Re: Comments on Significant Amendment to Aquifer Protection Permit No. P-512235 (LTF #101257) for South32 Hermosa, Inc.

On behalf of the Patagonia Area Resource Alliance (PARA), please accept these comments and objections to the request by South32 Hermosa, Inc. (South32) that the Arizona Department of Environmental Quality (ADEQ) issue a significant amendment to its Individual Aquifer Protection Permit (APP) No. P-512235 for the Hermosa Project mine located in Santa Cruz County, Arizona (Draft Permit or Permit).¹

Figure 1. Preliminary and short-term groundwater modeling results by South32 (2020).

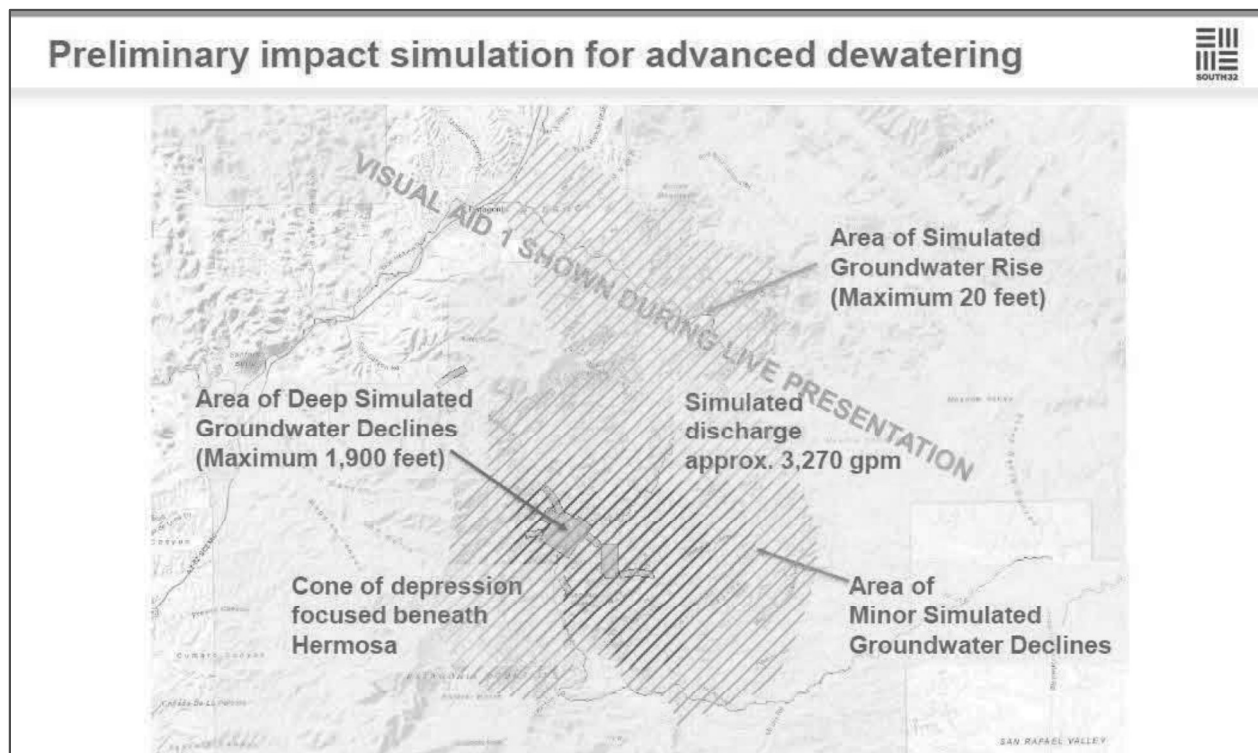
Although ADEQ (2021) proposes to grant AMI's Hermosa Project an APP for the "life of the facility (operational, closure, and post-closure periods)," AMI has neither confirmed the number of years for the life of the Hermosa Project, nor assessed the full life-of-mine impacts from both dewatering and long-term discharge to Harshaw Creek. AMI's APP application (AZ Minerals, Inc., 2020) refers to 30 years in several sections, but the company has provided no evidence that this time period corresponds to the expected life of this mine. The only groundwater modeling results AMI (South32) has presented publicly describing the effects of dewatering and discharge to Harshaw Creek were those in its July 2020 presentation on "Continued Exploration and Permitting" (Figure 1) (South32, 2020). In a subsequent meeting, South32 acknowledged that these results were preliminary and very short term and were based on findings from their exploratory drilling and test dewatering for approximately one month (T. Goode, pers. comm., 2021). The simulated discharge rate of 3,270 gpm for a few weeks does not approximate the proposed 4500 gpm for 4 years discussed in the Draft APP (ADEQ, 2021) and Draft AZPDES (ADEQ, 2021a) documents, and does not come close to assessing the 30+-year life of mine. The simulated impacts (up to 20 ft of groundwater-level increase across a 3-mile wide area centered on Harshaw Creek are not realistic for this small alluvial aquifer underlain by bedrock (see Section 3 and Figure 2).

AMI acknowledges that there is significant uncertainty regarding the deep sedimentary units that they intend to dewater. Projecting the results of a 1-month dewatering test out 4 to 30 years without any

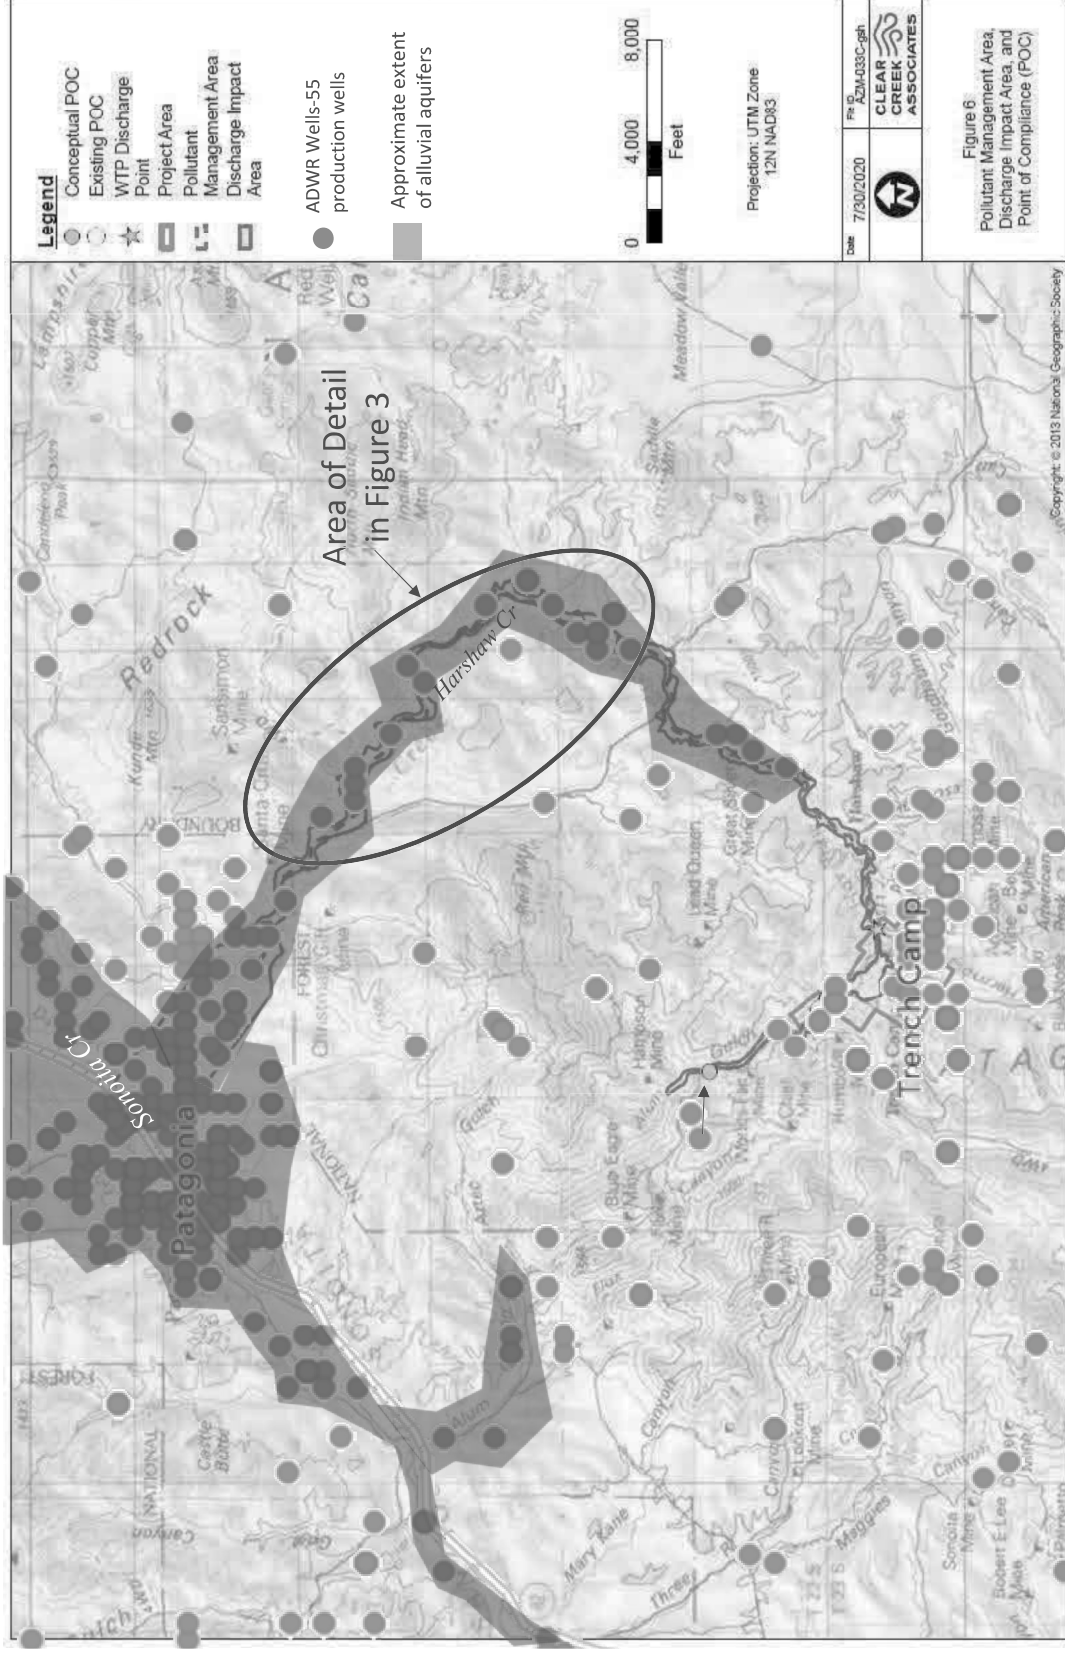
3. The lower Harshaw Creek alluvium and Sonoita Creek alluvium are both drinking water aquifers and, therefore, may not be degraded by mine discharge in a way that impairs existing or reasonably foreseeable uses of water in those aquifers.

Figure 2 overlays production wells from the Arizona Department of Water Resources (ADWR) Wells-55 database on AMI's proposed Pollutant Management Area (PMA)/Discharge Impact Area (DIA) map. Hundreds of private and community water system wells depend on the shallow alluvial aquifers in Harshaw and Sonoita Creek valleys. The blue shading in Figure 2 also shows the approximate extent of alluvial aquifers along Harshaw and Sonoita creeks and Alum Gulch within the figure area. Figure 3 provides details for several wells within the black oval in Figure 2. The details Figure 3 show that many wells along lower Harshaw Creek serve as drinking water sources as well as providing water for irrigation and livestock. Several of those wells are less than 40 feet (ft) deep, indicating likely development within the Harshaw Creek alluvial aquifer. Figure 4 illustrates groundwater levels over time for several drinking water wells and one monitoring well in the Town of Patagonia. Groundwater levels in this aquifer have historically ranged from less than 10 to just over 40 ft below ground surface. This shallow aquifer is particularly vulnerable to contaminant sources infiltrating through the Sonoita Creek streambed or migrating in the shallow subsurface from Harshaw Creek drainage.

Figure 5. Proposed PMA and DIA for Hermosa Project. Conceptual POC (orange circle) in Harshaw Creek is 9.4 miles below Outfall 2 on AMI property.

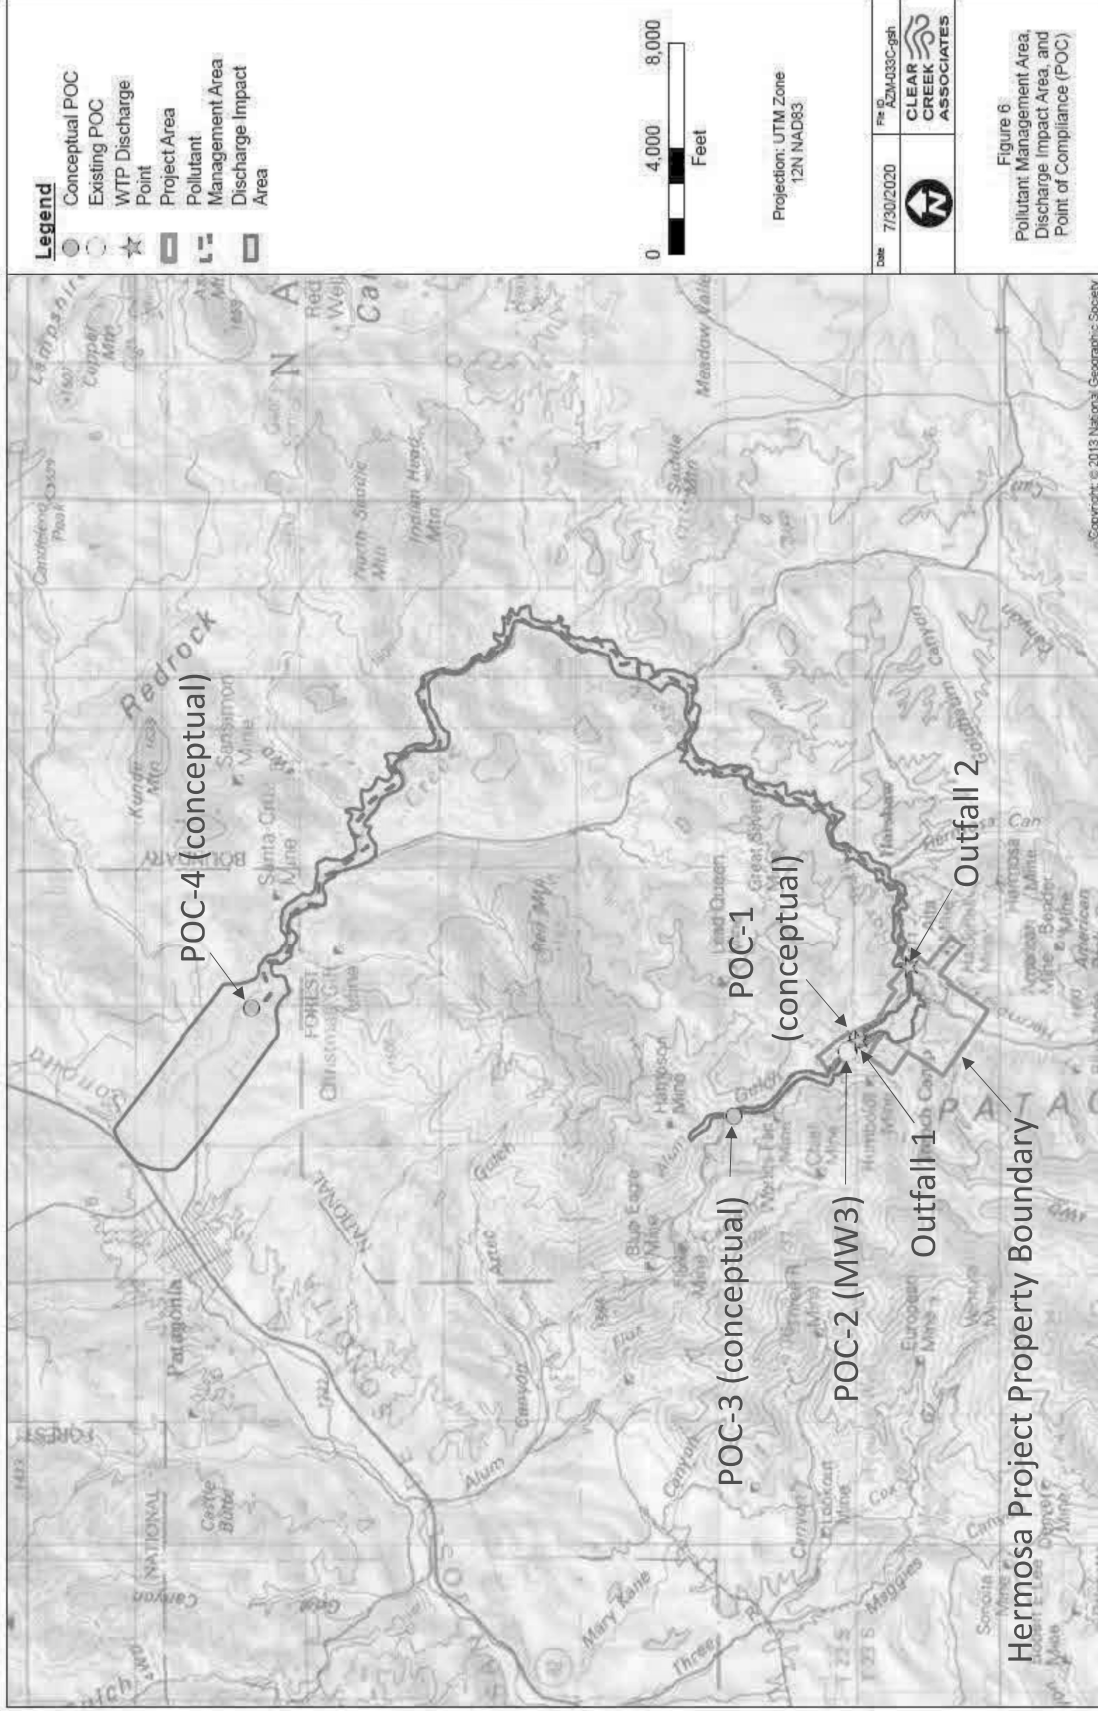
4. Additional Points of Compliance (POCs) with increased monitoring frequency are necessary to protect the health of downstream well owners and others who depend on groundwater from the sole-source drinking water aquifers in Harshaw and Sonoita creek valleys.

Figure 5 illustrates the proposed Hermosa Project PMA, Discharge Impact Area (DIA), and points of compliance (POCs) in Harshaw Creek and Alum Gulch. Details of the four proposed POCs are provided in Table 1. The only existing POC (POC-2) is a monitoring well (MW3) just below Outfall1 on Alum Gulch. The only proposed POC on Harshaw Creek is “Conceptual” POC-4 which is 9.4 miles downstream of Outfall2 on the Hermosa Project property. The placement of this conceptual POC coincides with the APP applicant’s (AMI’s) assertion that WTP2 discharge flows will not extend past this point. AMI provided no serious study of this issue, relying instead on several point measurements of infiltration rate over the course of just 3 days in October. Their highly abbreviated hydrologic study included no consideration for transient water-level or soil-moisture changes that will undoubtedly occur once AMI begins to discharge 4500 gpm into Harshaw Creek.

Under the proposed POC configuration, any contaminant release from the Hermosa Project property – whether from Outfall 1 or 2 or by other means – would not be monitored downstream until and unless the “conceptual” POC-4 were actually constructed. The only trigger to develop the “conceptual” POC-4 into an actual monitoring well is an alert level at WTP2 or possibly in a liner on under the tailings storage facility (ADEQ, 2021). Once an alert level is reached (through required monitoring only every 3 months), the Draft APP sets up months of verification sampling to ensure that the detected violation is “statistically significant.” After several months, if the violation is determined to be significant, then AMI would have to submit a design for the POC-4 well to ADEQ for review. Following ADEQ review, AMI would proceed with well construction and initiate monitoring. Meanwhile, the downstream drinking water aquifers in Harshaw and Sonoita Creek valleys would have been exposed to the contaminant stream for months, potentially causing a risk to human health, damage to well and drinking water infrastructure, and irreparable harm to these sole-source aquifers.

Figure 6. Production wells overlain on map of AMI's proposed PMA/DIA and POCs. Proposed additional POC-5 and POC-6 shown with yellow pentagons.

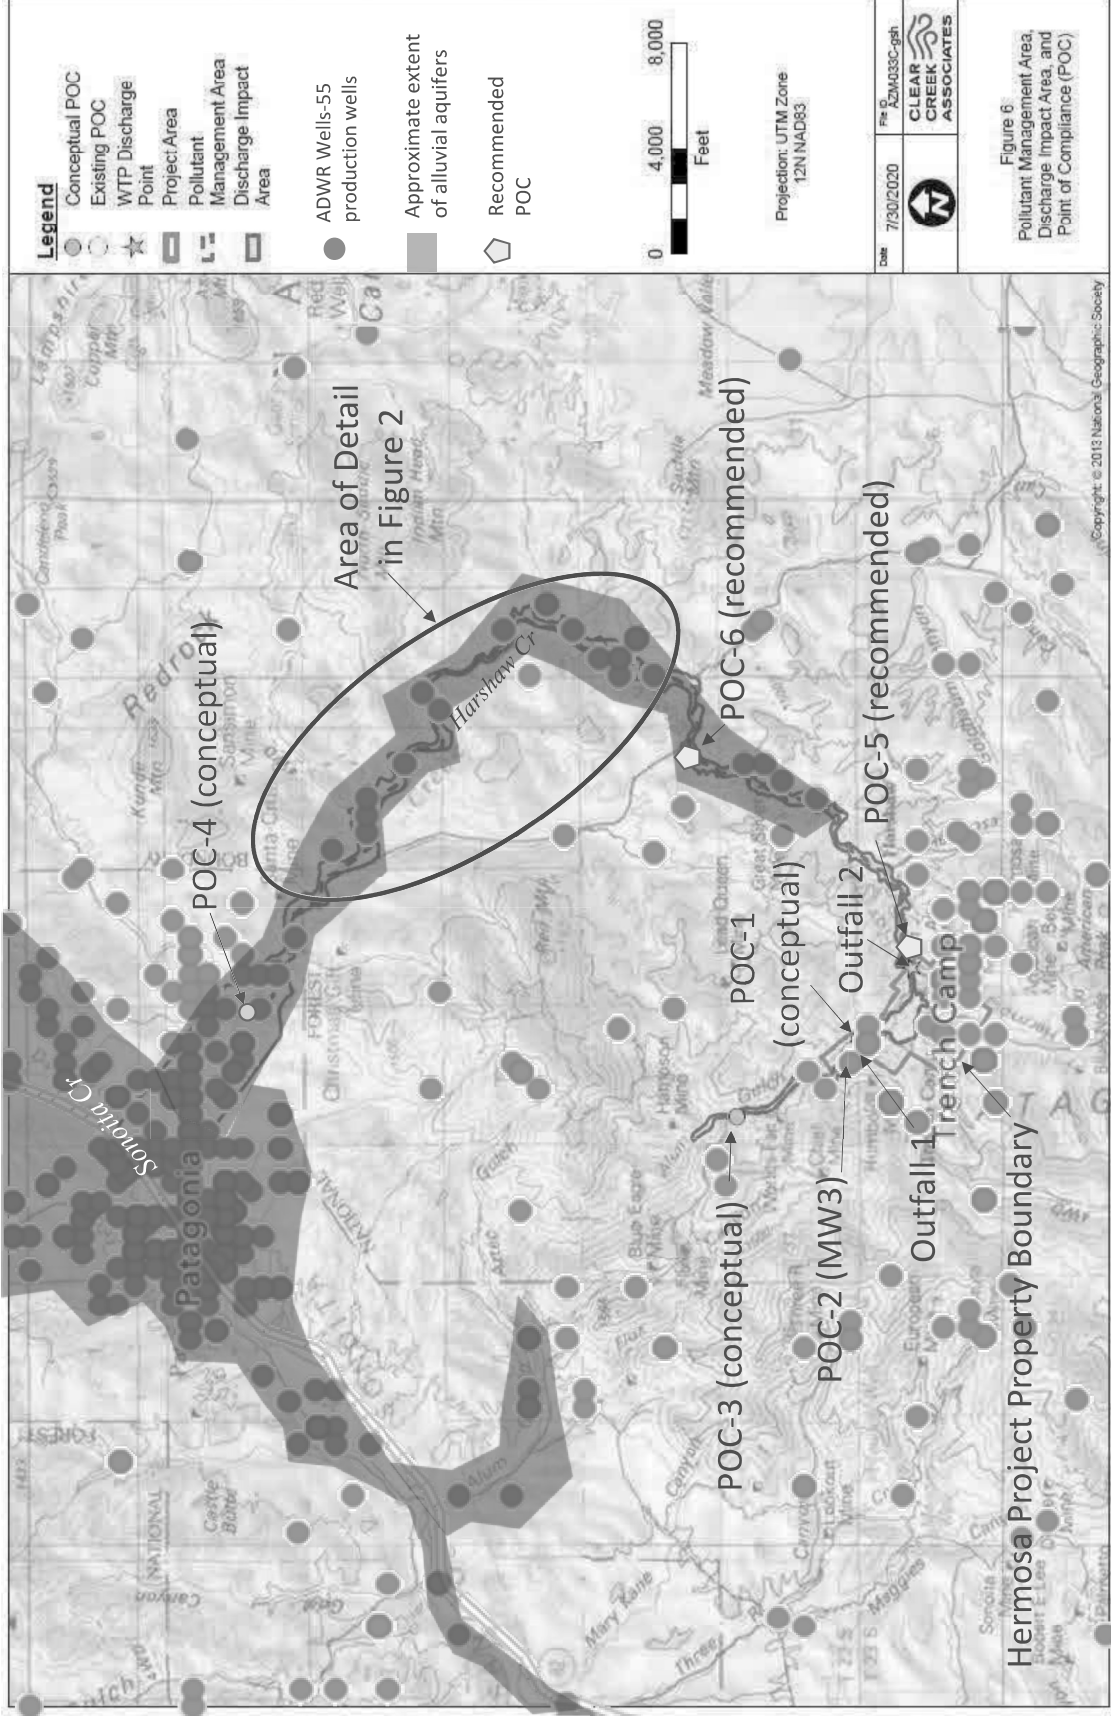
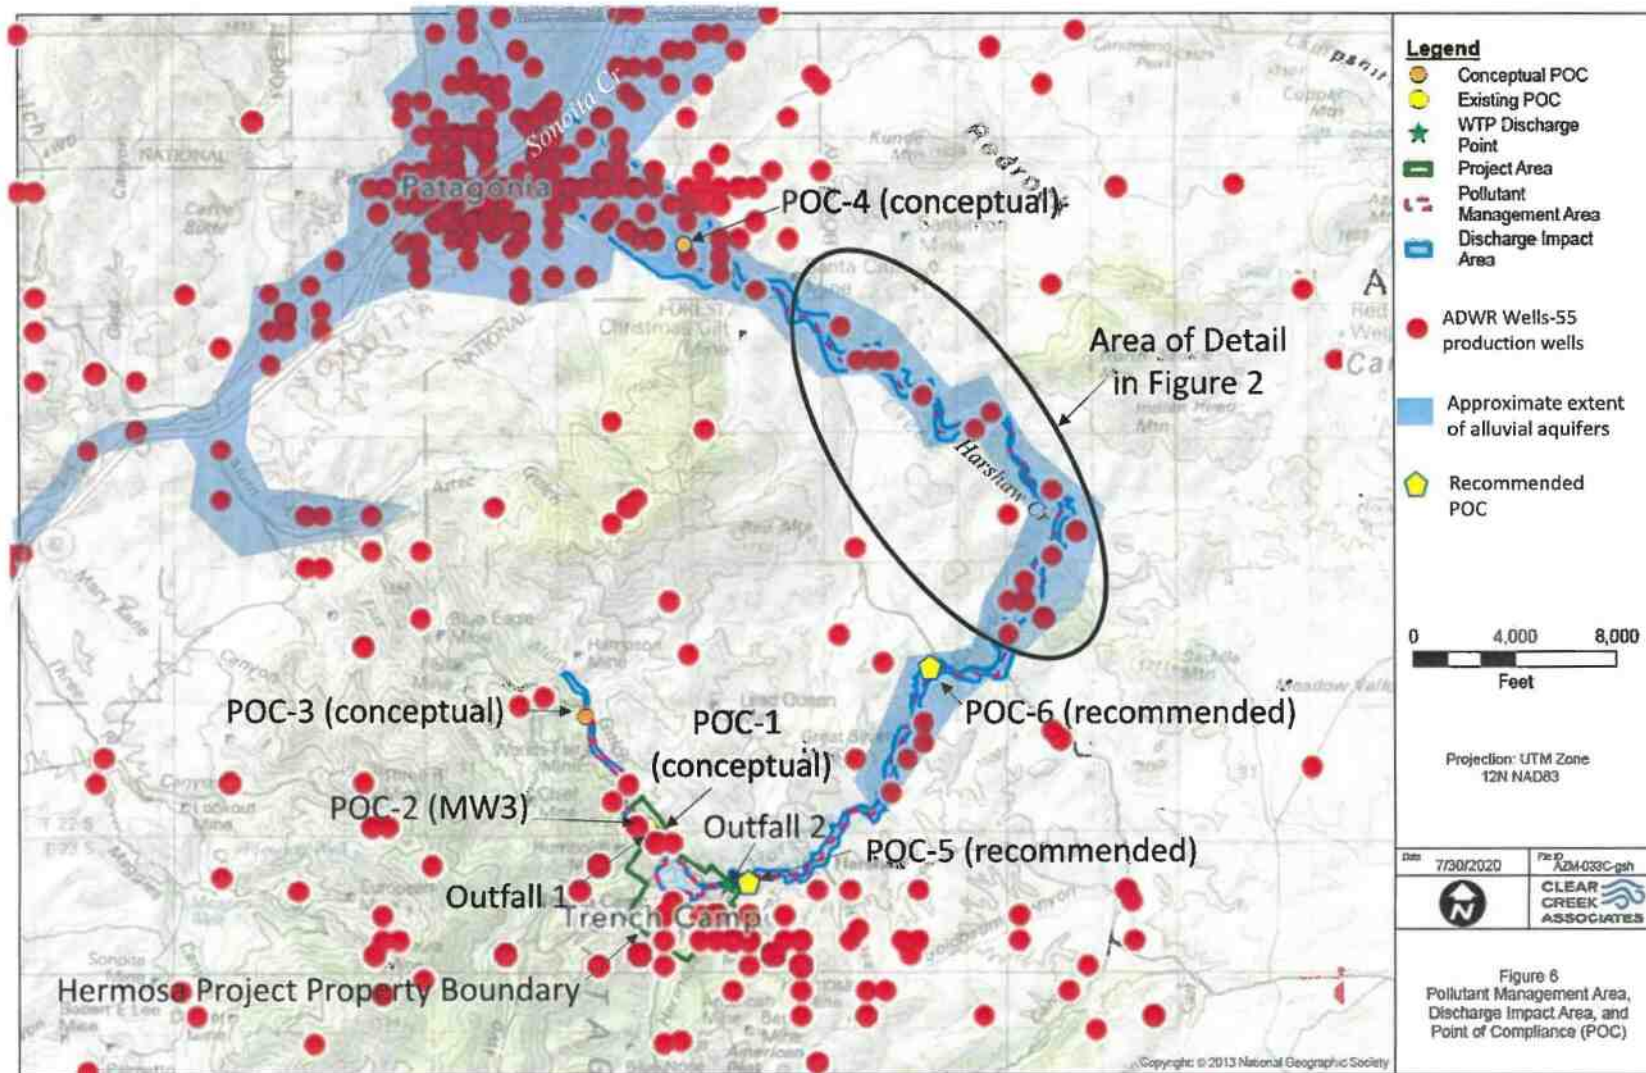
Figure 6 shows AMI's proposed PMA/DIA map with production wells and Draft APP compliance monitoring points from Table 1. Outfalls 1 and 2 represent discharge points for WTP1 and 2, respectively. In order to protect the downstream drinking water aquifers in Harshaw and Sonoita Creek aquifers, POC-4 should be constructed and additional POCs (POC-5 and POC-6) should be installed at the locations shown in Figure 6. As with POC-2, and as required by A.R.S. § 49-244, the POC below WTP2 (POC-5) should be immediately downgradient of the discharge point and within the Hermosa Project property boundary to provide the maximum early warning for any contaminants leaving the mine site. Because the Harshaw Creek drinking water aquifer lies less than two miles downgradient, another POC (POC-6) should be installed upgradient of the first shallow drinking water well, as shown in Figure 6.

The drinking water aquifers in Harshaw and Sonoita creeks are presently used without treatment other than disinfection. However, areas of "pH as low as 3.5 and dangerously high metal concentrations" in the groundwater of some parts of Harshaw Creek have been documented by (Brown, et al., 2020) and others. In order to comply with the standards set forth in A.A.C. R18-11-405, AMI should conduct a FULL hydrologic investigation of all downstream aquifers likely to be impacted by mine discharge, including those in Harshaw Creek and Sonoita Creek, to determine how increasing groundwater levels associated with Outfall2 discharge will affect existing groundwater levels and gradients and the water produced by drinking water wells in those aquifers. The proposed "Conceptual POC-4" must be converted to a REAL monitoring well to track both the release of contaminants from the Hermosa Project site AND any changes in downstream drinking water quality as a result of local contaminants within Harshaw Creek sediments and isolated areas of known high metals and low pH that may be liberated as a result of contact with the proposed 4500 gpm of discharge from WTP2.
